PLANNING COMMISSION AGENDA
City Commission Chambers - City Hall
625 Center Street, Oregon City, Oregon 97045
May 24, 2010 at 7:00 p.m.

FILE NO.: CU 10-01 – Conditional Use
SP 10-01 – Site Plan and Design Review

REQUEST: The applicant is seeking approval for Conditional Use and Site Plan and Design Review for a Religious Institution W/ a New Education Building and Pre-school for Atkinson Memorial Church.

project: Atkinson Memorial Church Education Building date: 3/26/10
documenting: Site Plan & Design Review – Parsonage Conditional Use

EXTERIOR ELEVATIONS
NORTH & EAST

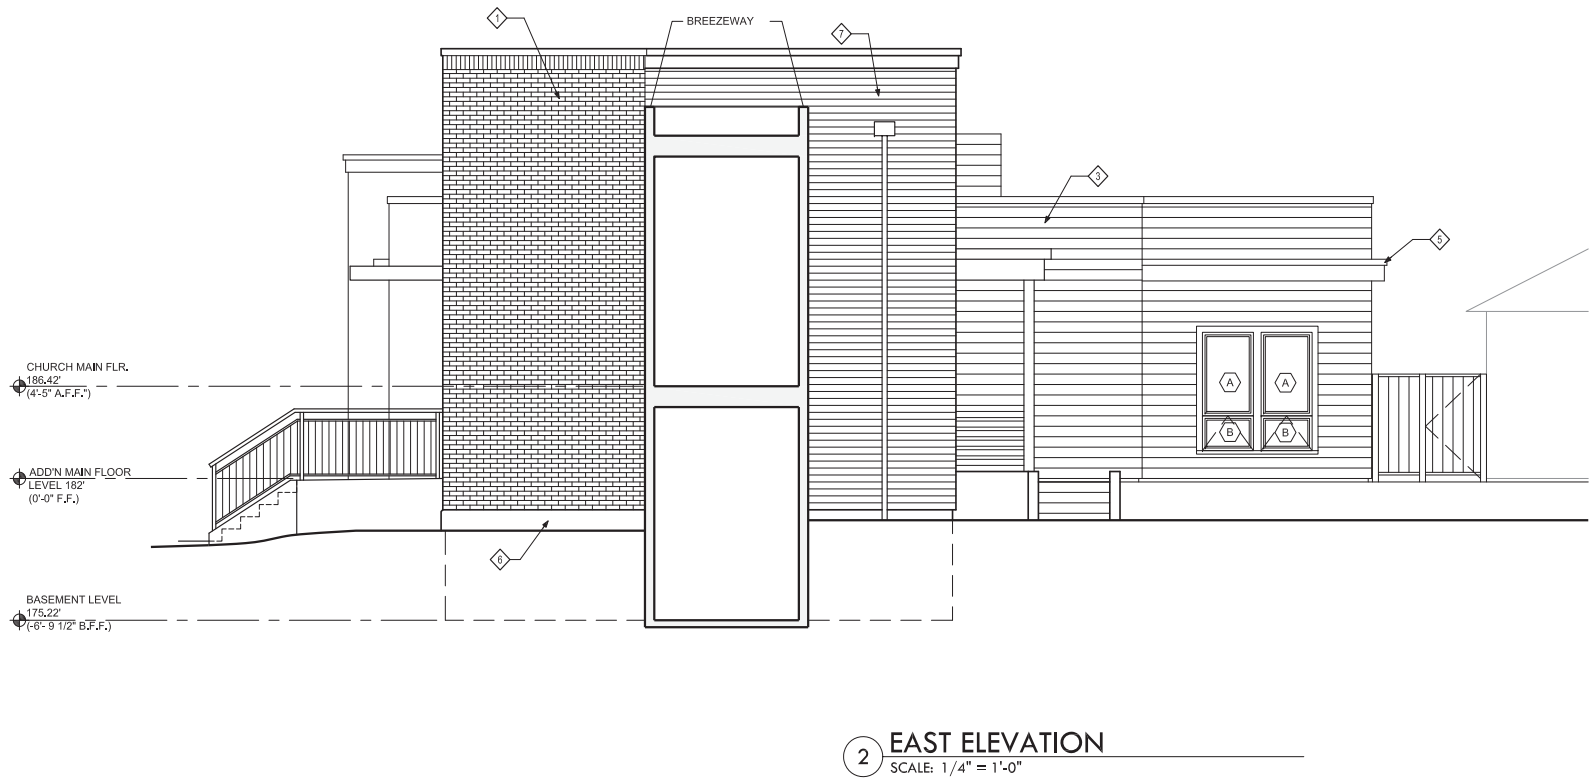
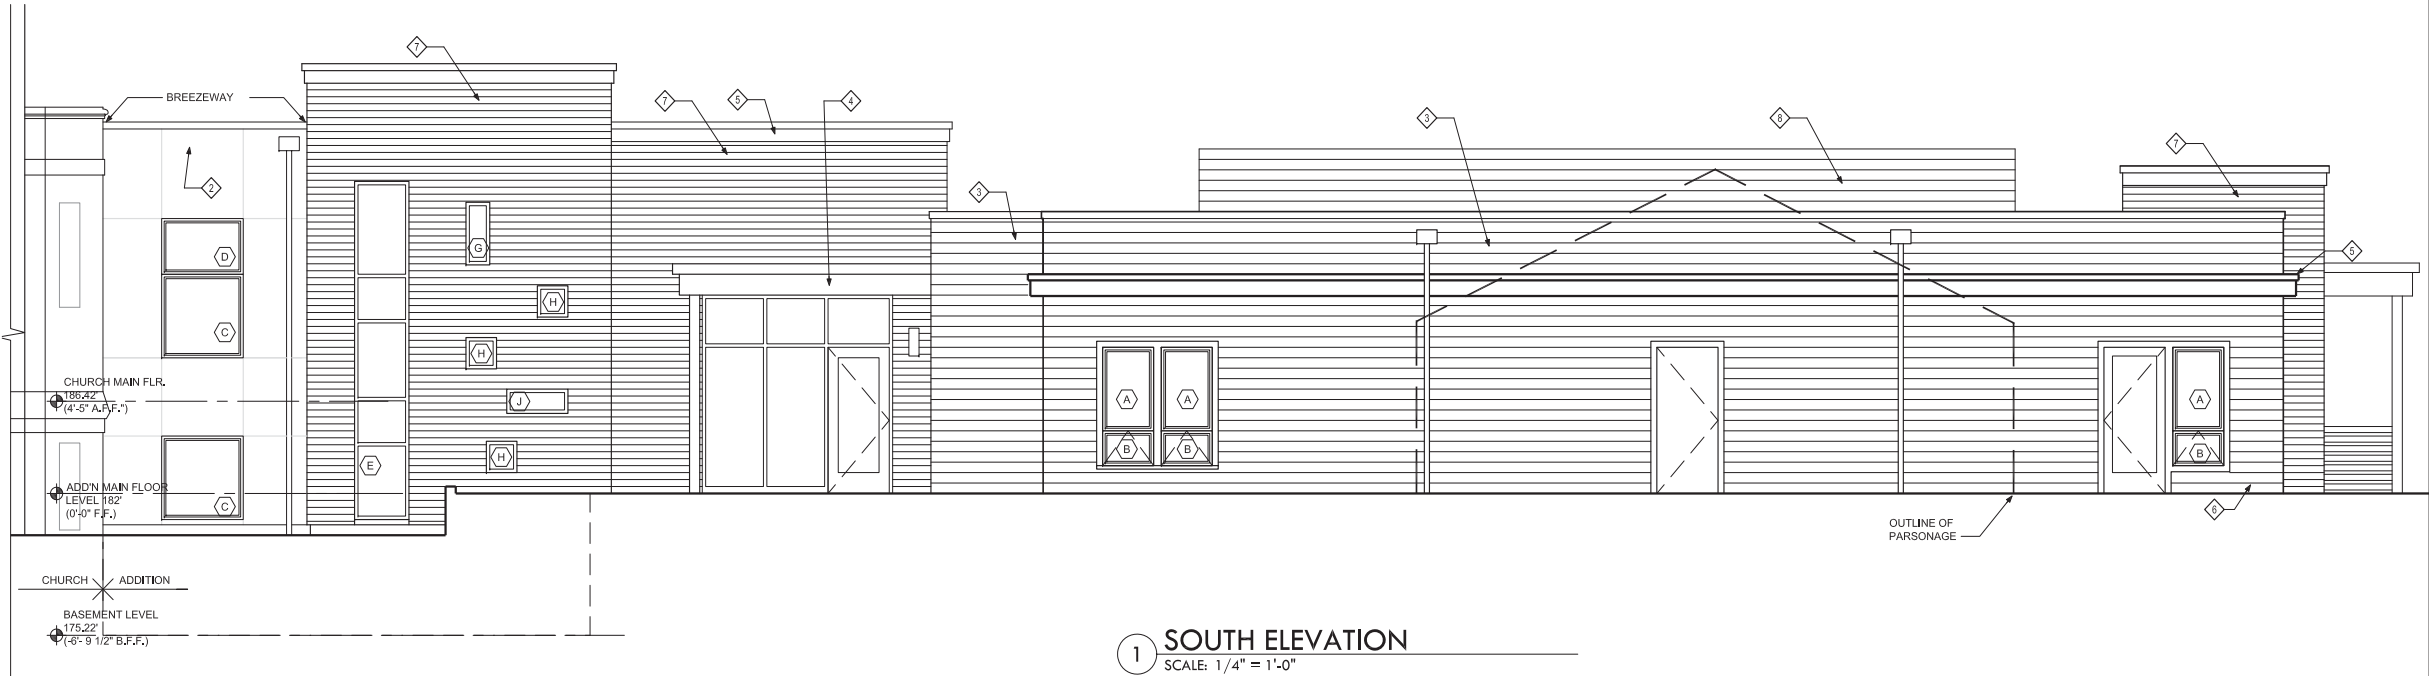
- e. Revised Exterior Elevations (Color) showing lap-siding instead of panel board, revised parapets, entrances, canopies, cornice caps, trim bands and window trim.

SITE PLAN

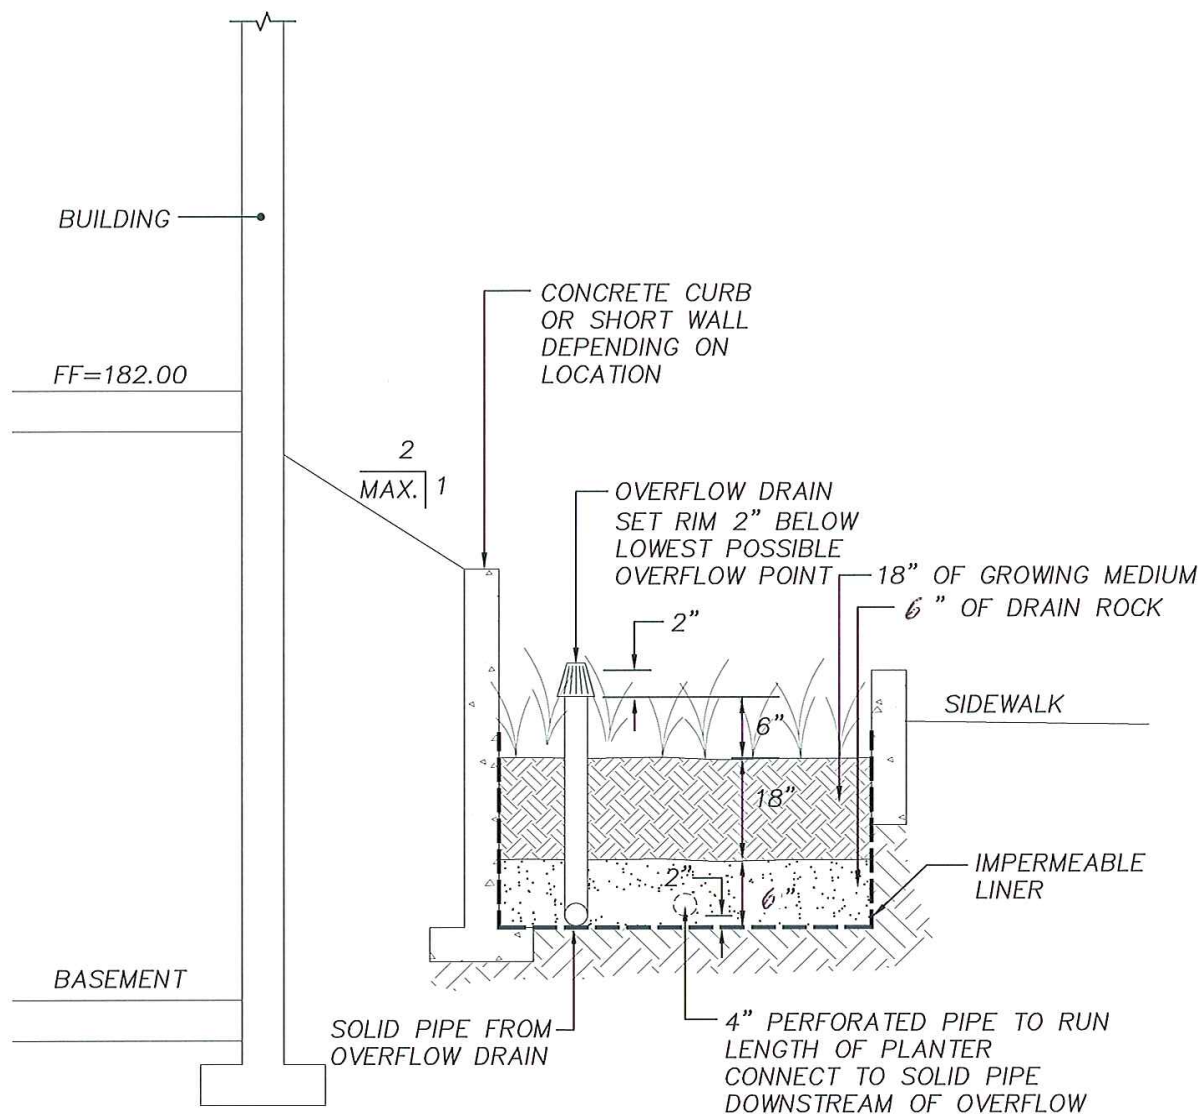
The statements 'city water bureau will perform the water taps' are false. You will find those statements on the proposed utility plan sheet C3.0. The owner shall contract that work performed and water division will inspect to insure that the work performed and material used meets city standards. Any existing H2O services shall be abandon at the water main (cut and capped) and old service line, angle stop, meter box and lid removed.
